Maverick County El Indio Landfill Maverick County, Texas TCEQ Permit No. MSW-2316

Permit Modification Application

Volume 1 of 2 Marked Version

Subject: Maverick County El Indio MSW Landfill - Maverick County Municipal Solid Waste - Permit No. 2316 Permit Modification Application – Surface Water Drainage, Final Contours, and Geology/Geotechnical RN105513030 / CN603354721

EXHIBIT 1 - AIRSPACE EVALUATION

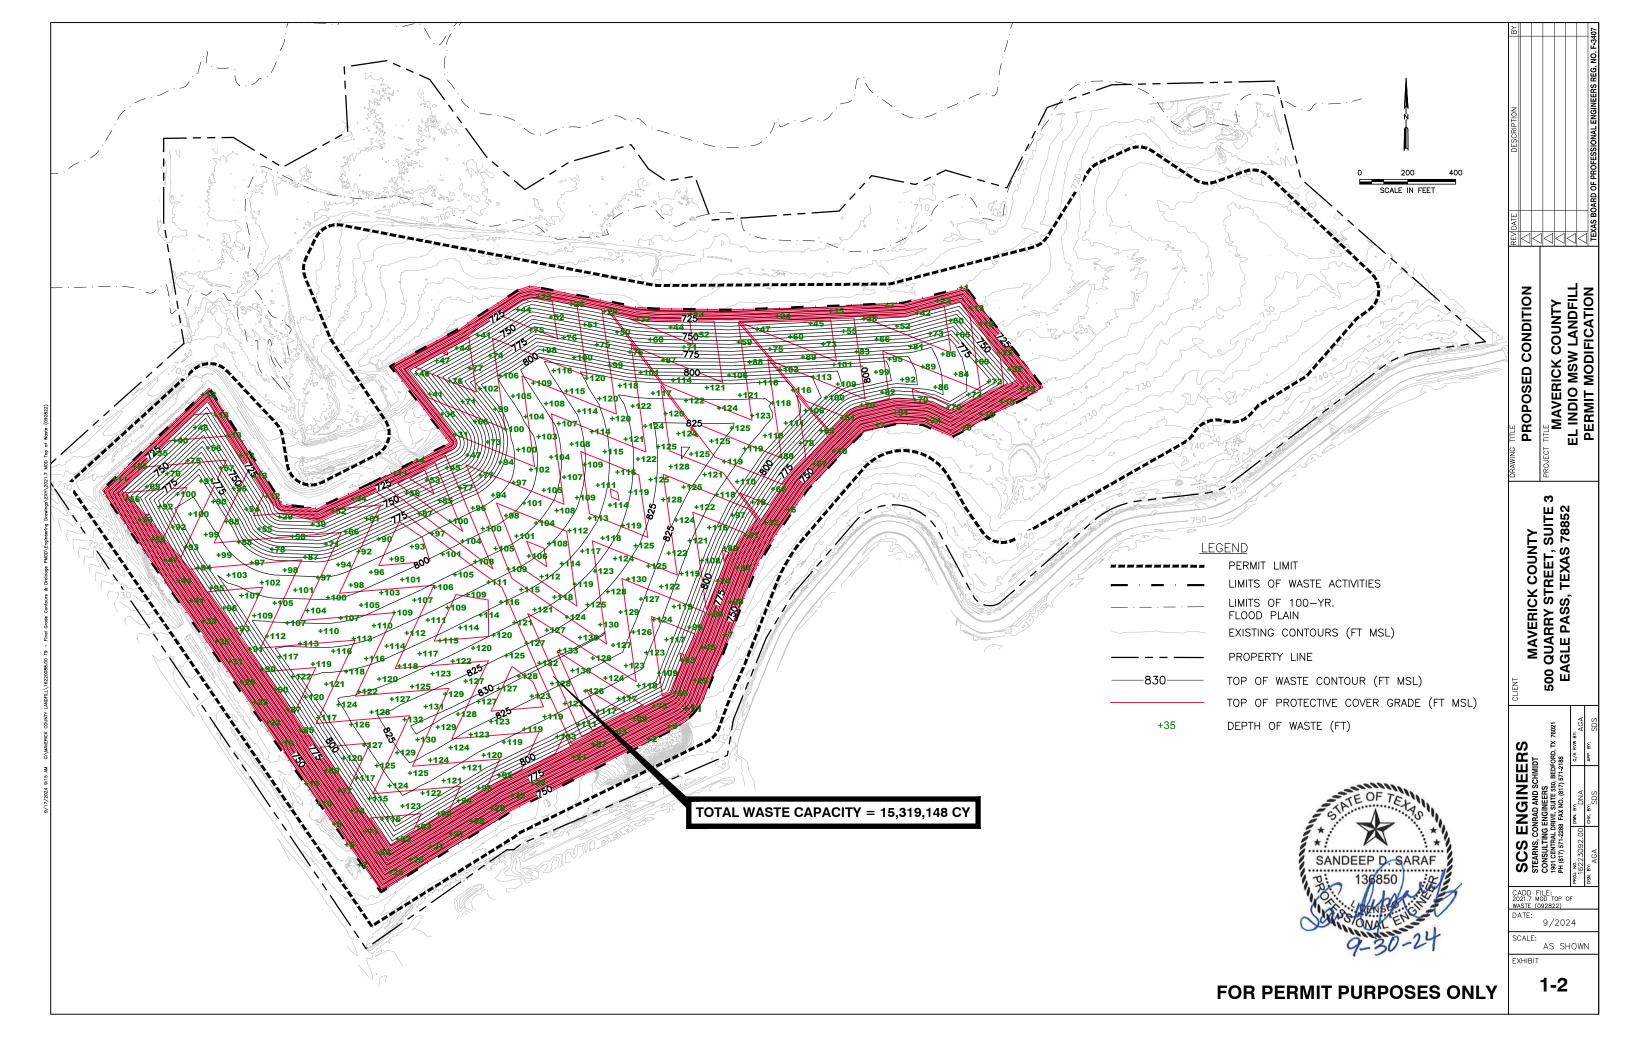
Exhibit 1-1 graphically shows the total permitted landfill waste capacity calculated to be **15,362,437 CY**. Exhibit 1-2 graphically shows the total proposed landfill waste capacity calculated to be **15,319,148 CY**. Based on these calculations, the proposed top of waste grading plan results in an approximate **net waste airspace loss of 43,289 cubic yards when compared to permitted top of waste surface grading plan.**

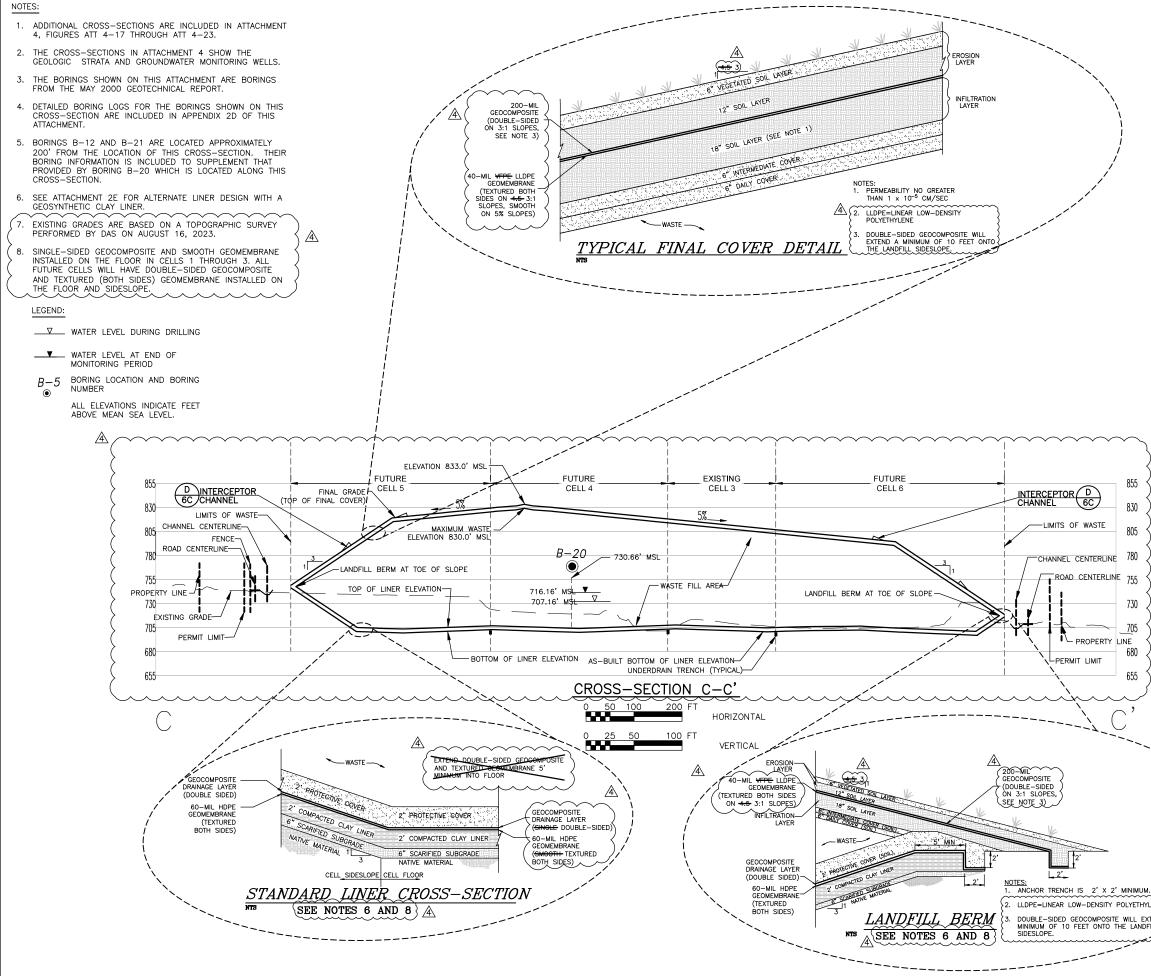
Image: Note of the construction of the constructine of the constructine of the constructine of the constructine of	SCS ENGINEERS SCS ENGINEERS DATE: DATE: SCALE:	MAVERICK	DRAWING TITLE CROSS-SECTION B-B'	DESCRIPTION REVISED SECTION TO NEW FINAL FILL GRADES ANDER A DATE & DECEDENCE & NATE	
	CONSULTING ENGINEERS 1901 CENTRAL DRIVE SURFESSA. REDFORD, TX 76 1901 CENTRAL DRIVE SURFESSA. REDFORD, TX 76 1617 517-2388 FAX NO. (817) 517-2388 162233092.00 162233092.00 162223092.00 162233092.00 162223092.00 162233092.00 1632 1632 1632 1632 1632 1632 1632 1632 1632 1632 1632 1632 1632 1632 1632 1632 1632 1632 1632 1633 1633 1633 1634 1635 1635 1635 1635 1635 1635 1635 1635 1635 1635 1635 1635 1635	500 QUARRY STREET, SUITE 3 EAGLE PASS, TEXAS 78852	PROJECT TITE MAVERICK COUNTY EL INDIO MSW LANDFILL PERMIT MODIFICATION	& NULL EPLACED VFPE WITH DESLOPE TO 3H:1V; NEERS REG. NO. F-34

REVDATE DESCRIPTION BY ▲7/10 ADDED NOTE 6 REFERENCE & NOTE: REVISED RK ↓ DETAIL TITLE	9/24 9/24
SANDEEP D. SARAF B. 136850 CHASSION SARAF B. 136850 CHASSION SARAF B. 136850 CHASSION SARAF B. 136850 CHASSION SARAF B. 136850 CHASSION SARAF	ROSS-SECTION C-C	PROJECT TITLE MAVERICK COUNTY EL INDIO MSW LANDFILL PERMIT MODIFICATION TE
		500 QUARRY STREET, SUITE 3 EAGLE PASS, TEXAS 78852
		CONSULTING ENGINEERS 1991 CENTAL DIVE, SUITE 560, BEDFORD, TX 76021 PHR01, NG, 1771-2289 FAX.00. [817] 571-2289 FAX.00. [
FOR PERMIT PURPOSES ONLY	ATTACH	AS SHOWN MENT 2C

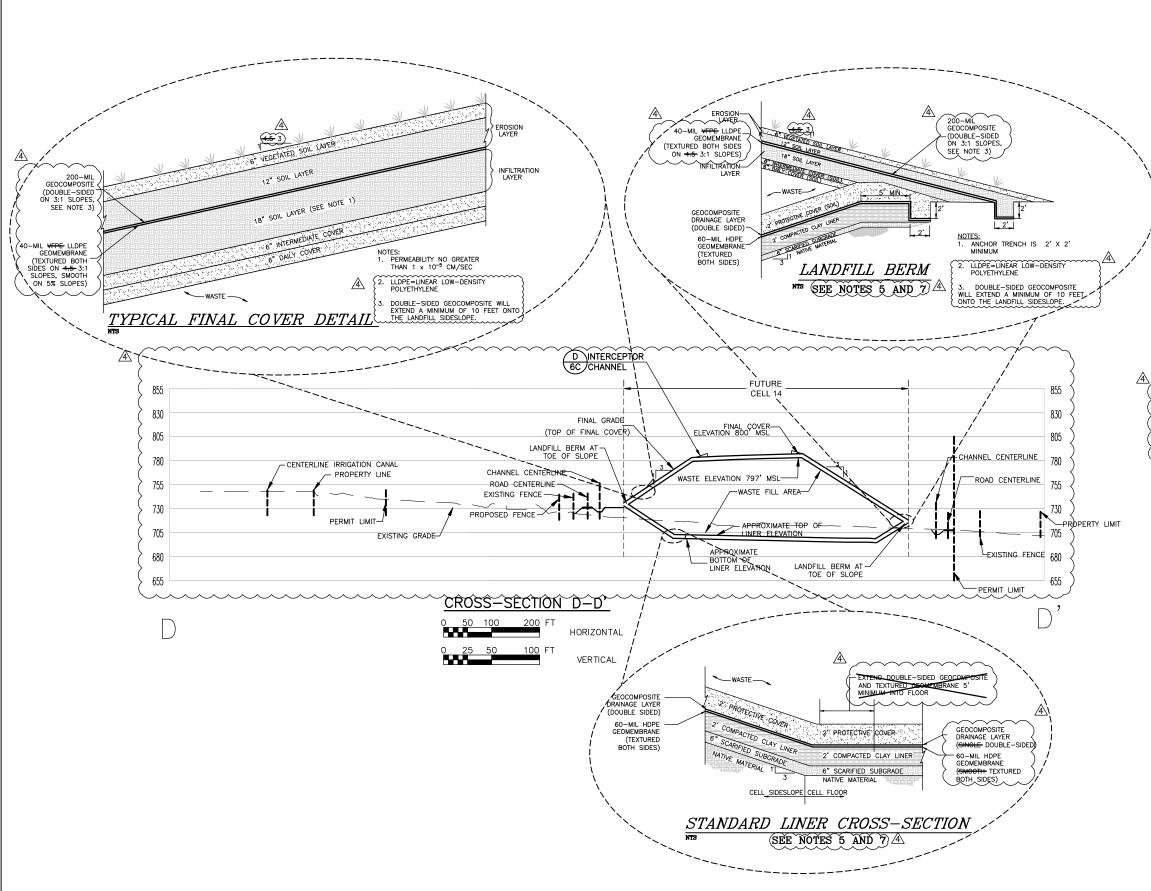
REVIDATE DESCRIPTION BY A 7/10 ADDED NOTE 8 A FILIDE 5 REFERENCE 8 NOTE RK	A 10/10/REVISE PROJECT TITLE RK A 9/24 ADED GEOCOMPOSITE IN FINAL COVER; REPLACED VFPE SS SS A VTH LIDPE GEOCOMPOSITE IN FINAL COVER; REPLACED VFPE SS SS SS A VTH LIDPE GEOMEMBRANE; CHANGED SIDESLOPE TO SS SS A SH: IV. UPDATED CELL FLOOR UNRE DETAIL TEXAS BOARD OF PROFESSIONAL ENGINEERS REG. NO. F-3407
NOTES: 1. ADDITIONAL CROSS-SECTIONS ARE INCLUDED IN ATTACHMENT 4. FIGURES ATT 4–17 THROUGH ATT 4–23. 2. THE CROSS-SECTIONS IN ATTACHMENT 4 SHOW THE GEOLOGIC STRATA AND GROUNDWATER MONITORING WELLS. 3. THE BORINGS SHOWN ON THIS ATTACHMENT ARE BORINGS FROM THE MAY 2000 GEOTECHNICAL REPORT. 4. DETAILED BORING LOGS FOR THE BORINGS SHOWN ON THIS CROSS-SECTION ARE INCLUDED IN APPENDIX 2D OF THIS ATTACHMENT. 5. SEE ATTACHMENT 2E FOR ALTERNATE LINER DESIGN WITH A GEOSYNTHETIC CLAY LINER. 6. EXISTING GRADES ARE BASED ON A TOPOGRAPHIC SURVEY PERFORMED BY DAS ON AUGUST 16, 2023. 7. SINGLE-SIDED GEOCOMPOSITE AND SMOOTH GEOMEMBRANE	DRAWING TITLE CROSS-SECTION D-D'	PROJECT TITLE MAVERICK COUNTY EL INDIO MSW LANDFILL PERMIT MODIFICATION

$[\underbrace{\text{INSTALLED ON THE FLOOR IN CELLS 1 THROUGH 3. ALL} FUTURE CELLS WILL HAVE DOUBLE-SIDED GEOCOMPOSITEAND TEXTURED (BOHT SIDES) GEOMEMBRANE INSTALLED ONTHE FLOOR AND SIDESLOPE. [\underbrace{\text{LEGEND:}} \\ \hline \\$		500 QUARRY STREET, SUITE 3 EAGLE PASS, TEXAS 78852
ABOVE MEAN SEA LEVEL.		09/2024 AS SHOWN
FOR PERMIT PURPOSES ONLY		2 D
